**Network Rail carbon review**

AO/042 Review of Network Rail's  
carbon reduction calculations and  
CP5 trajectory

Issue | 21 May 2013

Figure 2 Network Rail’s carbon reporting model

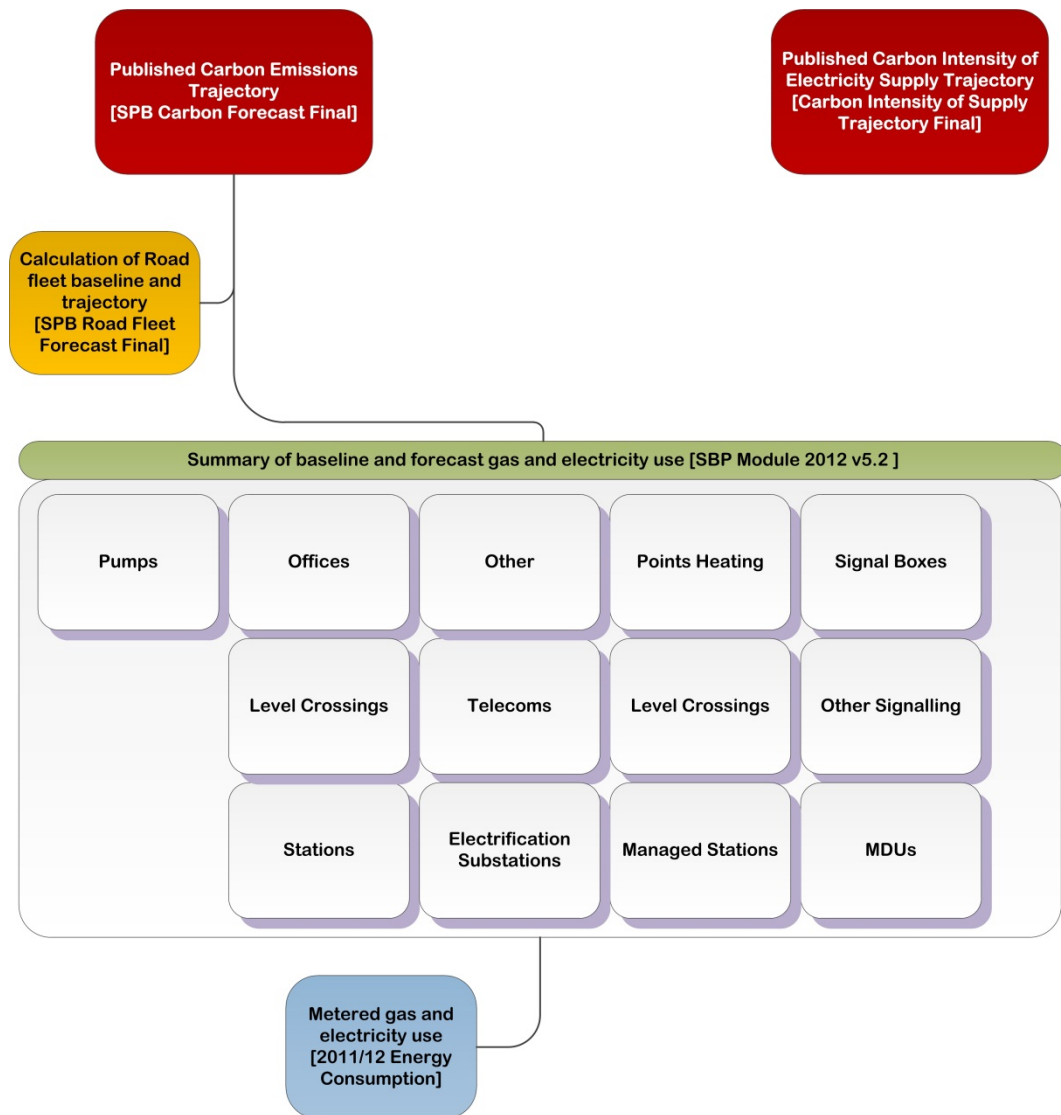
NR's carbon footprint is based on recorded (automated and manual readings) energy consumption figures for all 13 assets illustrated in Figure 2. These are referred to as input data from hereafter. Input data is then converted into carbon emissions using published factors. This process has been well documented for all assets with only some minor shortcomings:
